Shift Interrupt Diode Replacement Kit P/N 17461A5 - 225

Mariner/Mercury 1994 225 S/N 0D280813 thru 0G129221 Shift Interrupt Diode Kit P/N 17461A5

A Shift Interrupt Diode Kit P/N 17461A5 has been designed to replace a failed shift interrupt diode without replacing the main engine harness.

Figure 1. Shift Interrupt Diode Location.

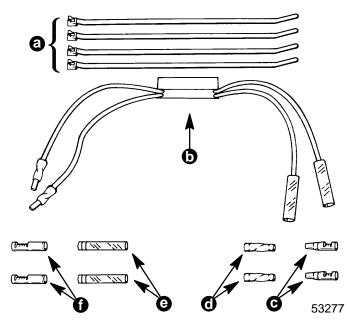
The diode in the main engine harness, allows the shift interrupt switch to shut off ignition on cylinders 2, 4, and 6 (port side CDMs) when shifting in and out of gear. It also allows all cylinders to be shut off with the key switch.

The replacement kit consists of a diode module that will be installed in place of the failed diode in the main engine harness and will remain external from the harness.
